QUESTIONS & ANSWERS (Total 4 pages)

**SOLICITATION # SKU20016Q0021 – PALM TREE REPLACEMENT PROJECT.**

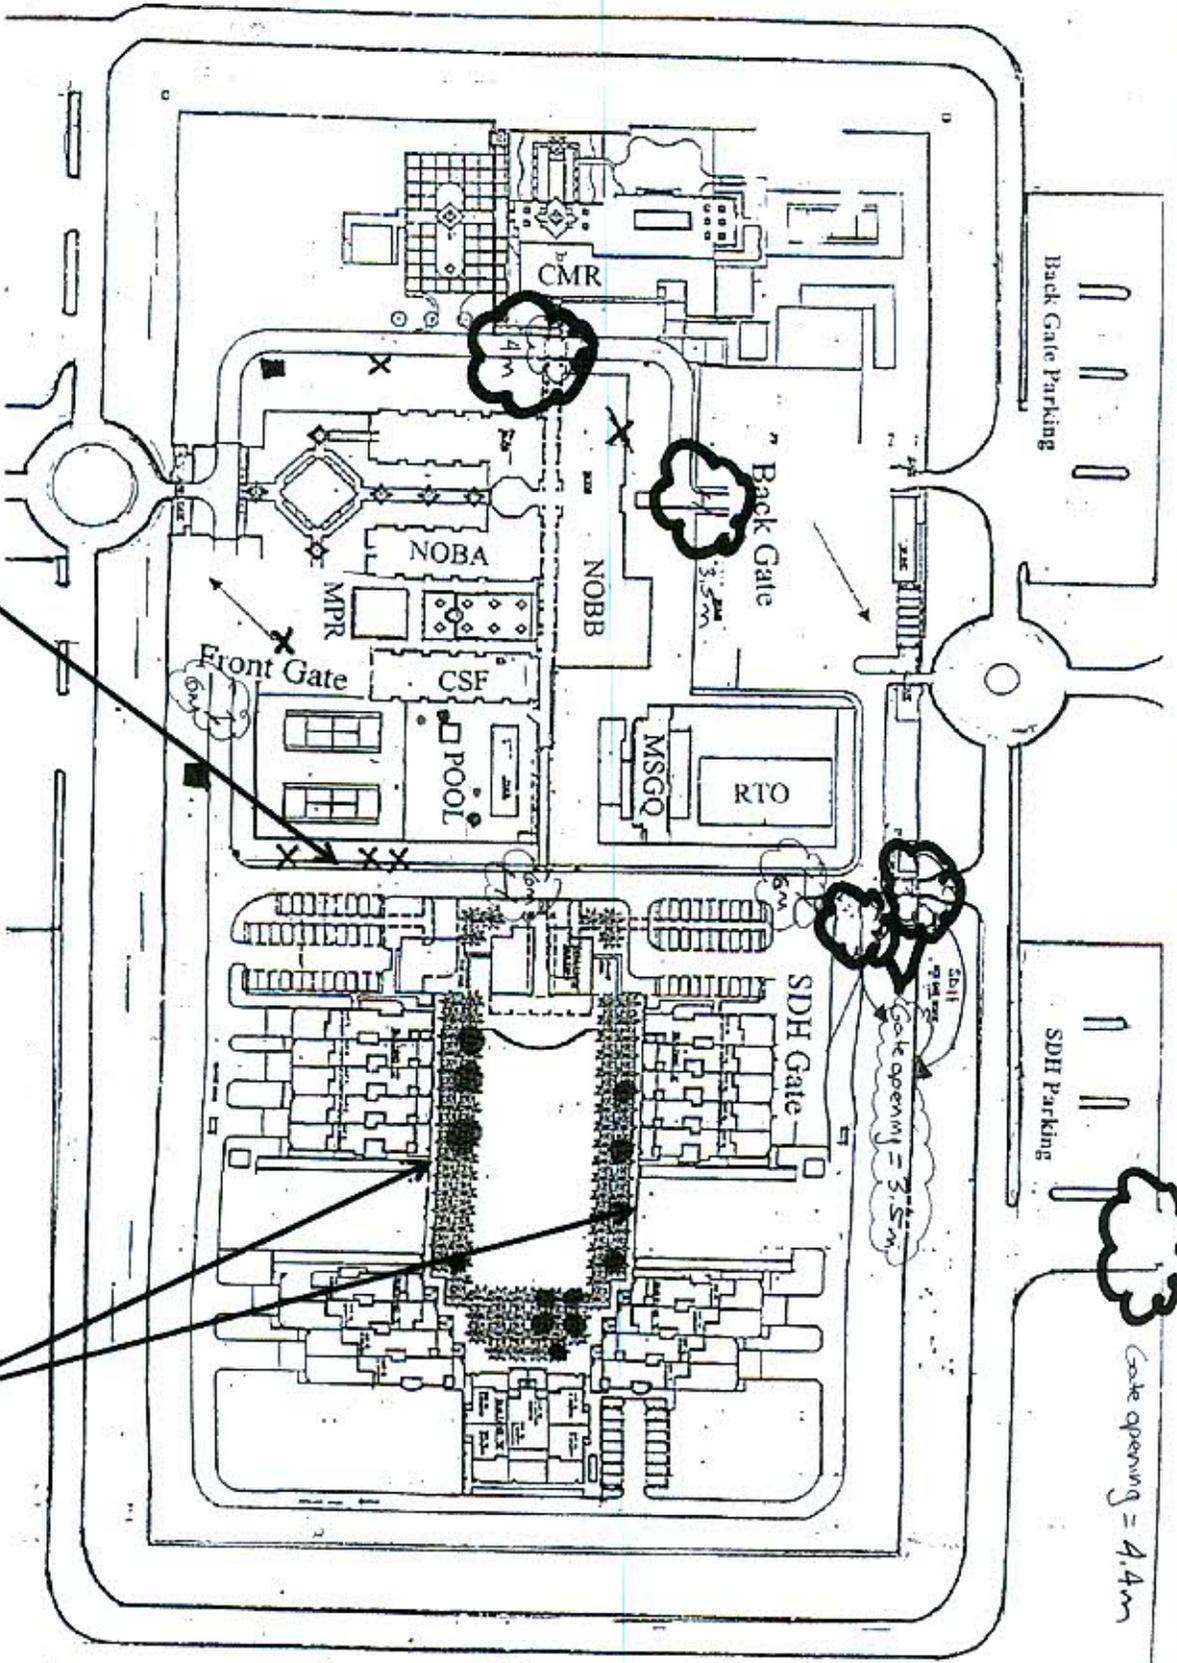
Question	Answer
1. Could you provide us the internal road dimension (length & width) , because we have to make sure that the crane can smoothly move inside the compound with no difficulties or obstacles. If you can mark it in the same attachment, it would be really helpful.	We are providing attached dimensions of “pinch points” for cranes, etc. (Refer to the attached Map) The winning contractor would need to perform a pre-construction walkthrough where they would review their installation plan and could fine tune at that point.

7. Can you state how many U.S. Small Businesses of any type are now interested bidders ?	The U.S. Embassy does not carry this information.
8. Can you provide distances for the widths of the paths bordering the tree installation points for all locations. ATTCHD is same site map with arrows and questioned widths.	1. Width of sidewalk from the adjacent wall to the grass area: 10'-6" 2. Width of sidewalk near the pool 5'-8" 3. Not asked but useful information – “free space” width of the gates leading into the SDH area from the grassy areas is 5'9” up to 6'-1” depending on the gate.

What is the width of sidewalk or path near pool ?

What is the width of the path on both sides bordering the palm trees ?

5'-8"

10'-6"

Gate opening = 4.4m

Gate opening = 3.5m
